Peer Review Strada Enclosures (June 2025)

Supporting Exhibits

The following exhibits are enclosed in support of Fifth Cycle Peer Review Comments. These exhibits also support the simultaneous Peer Review of the Site Plans. The reader is advised to review the Exhibits prior to the text.

Table 6.1: Summary of water management fluxes.

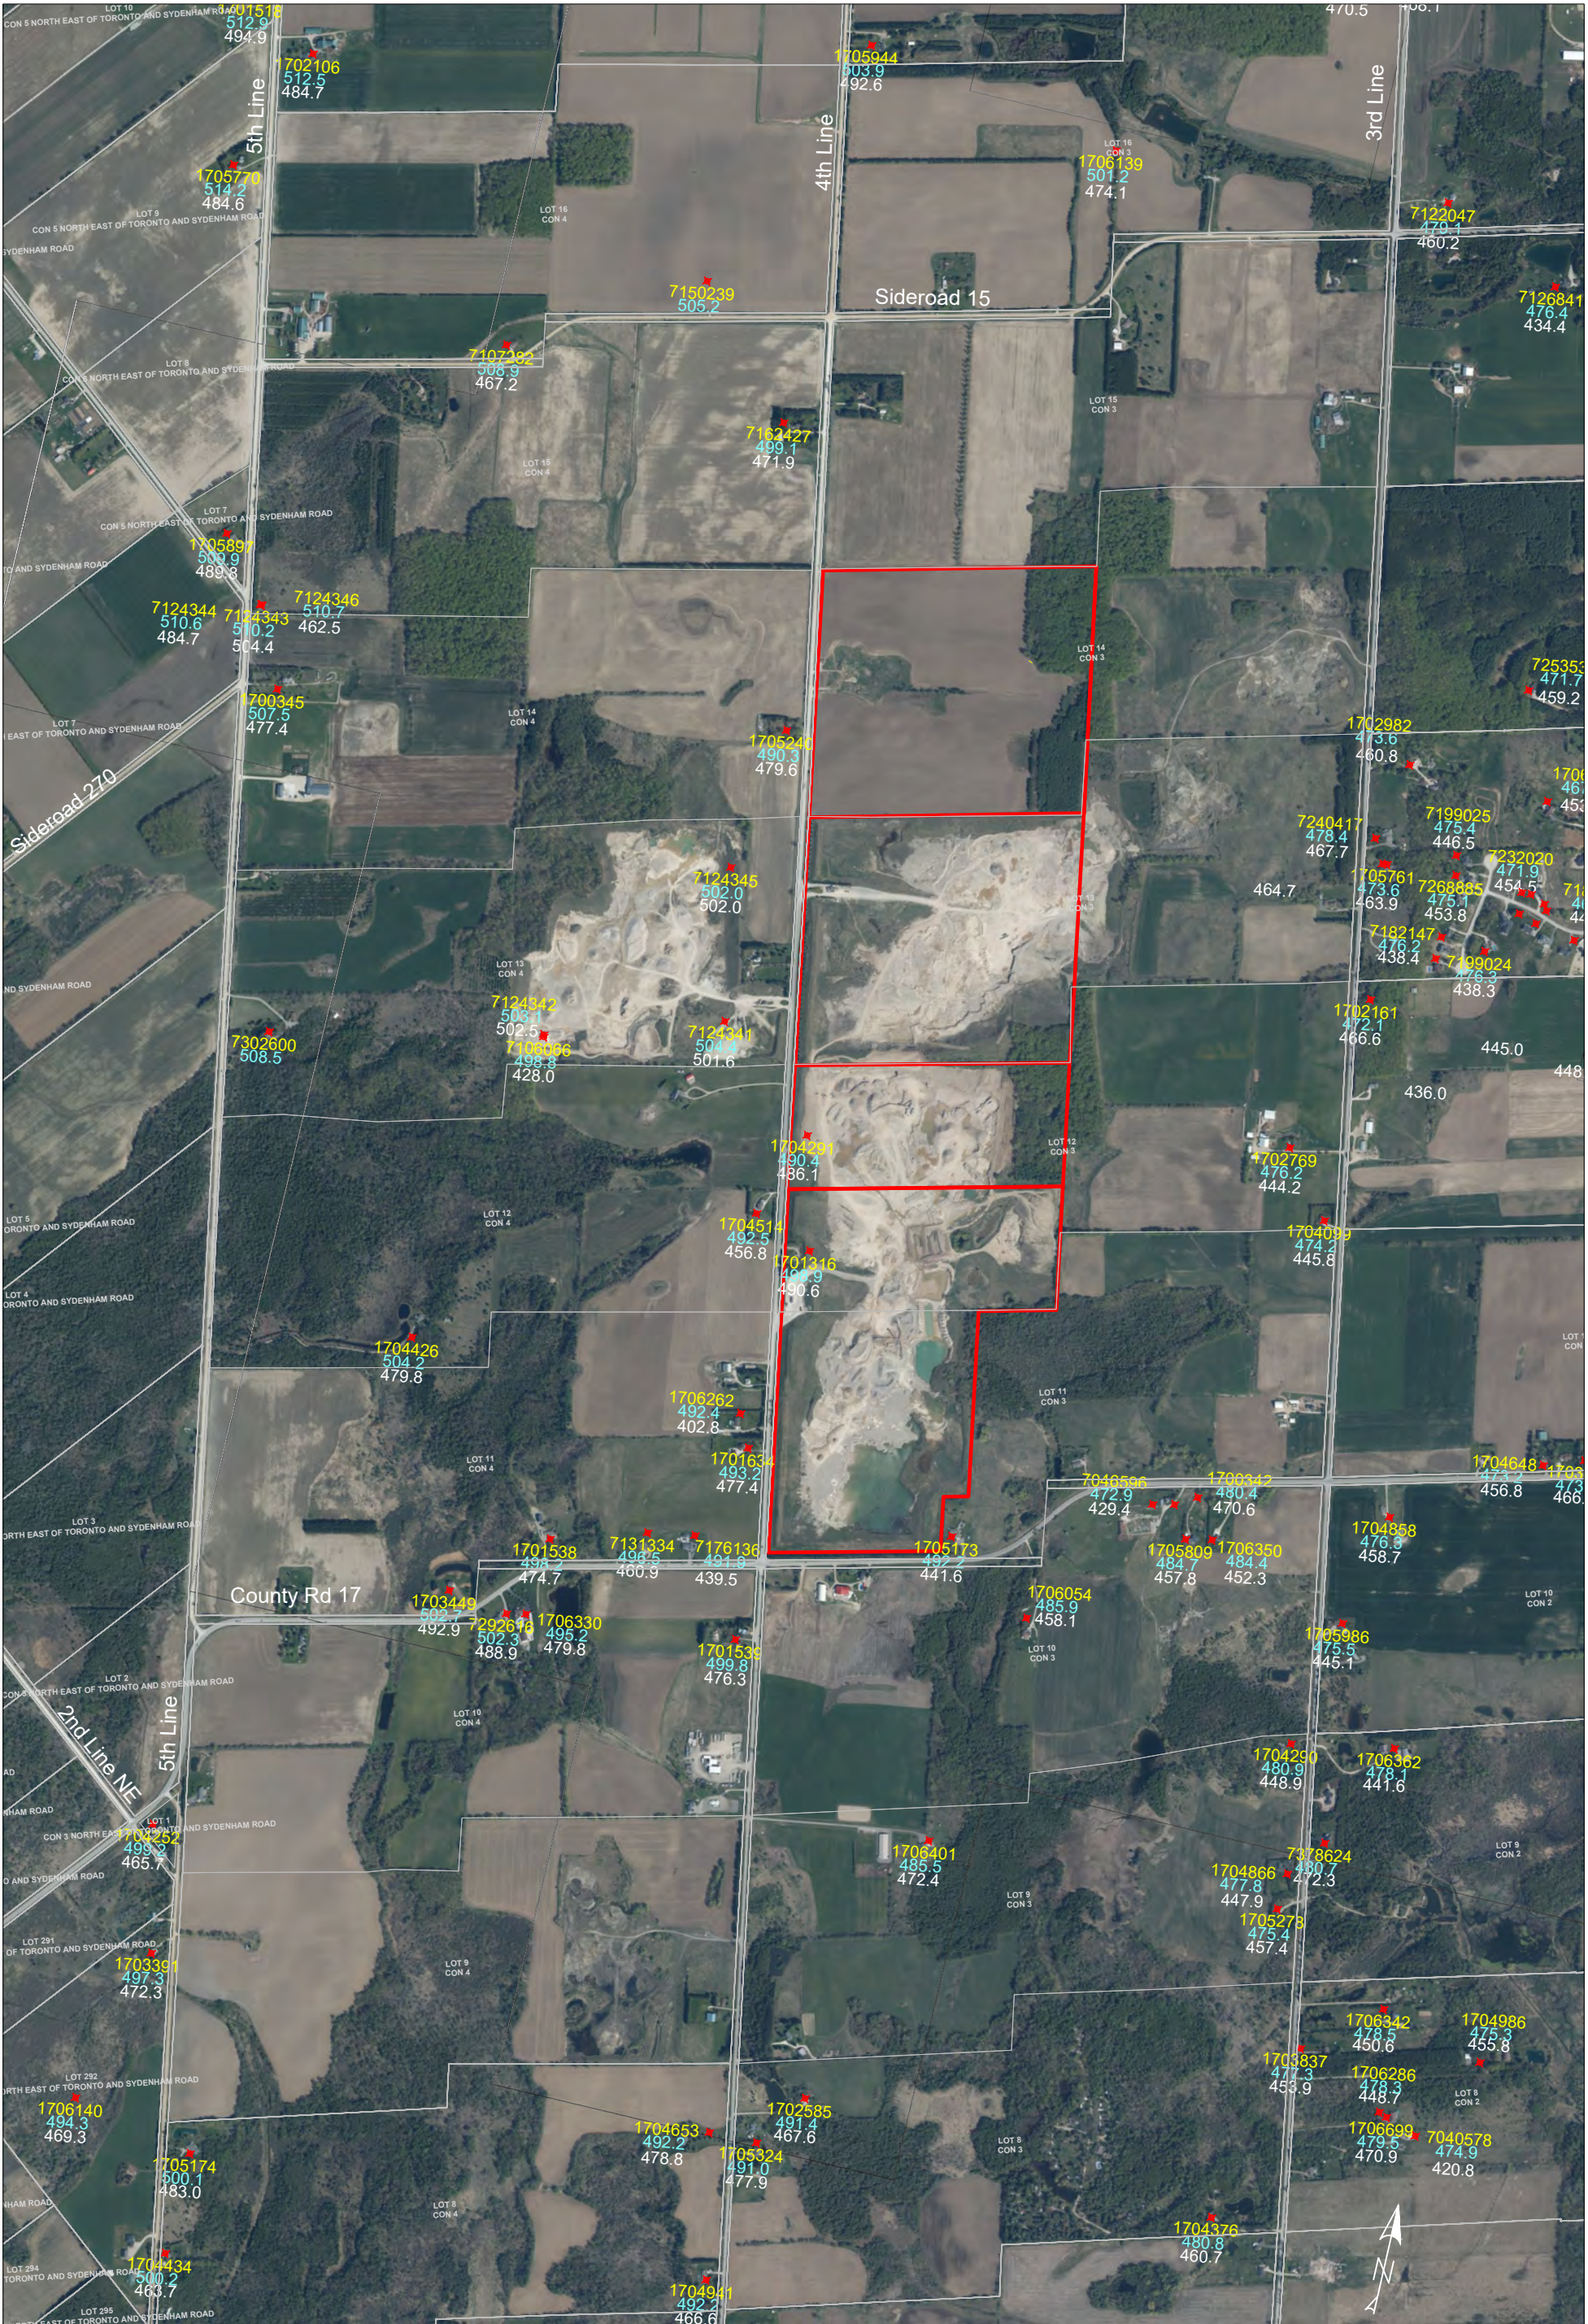
Model Phase 2 C Total Flow (flux) from the Quarry is estimated at 71 L/s or 6,100 m³/day.

- **Shelburne ~ 2,200 m³/day**
- **Fergus Elora ~5,800 m³/day**
- **Orangeville ~8,200 m³/day**
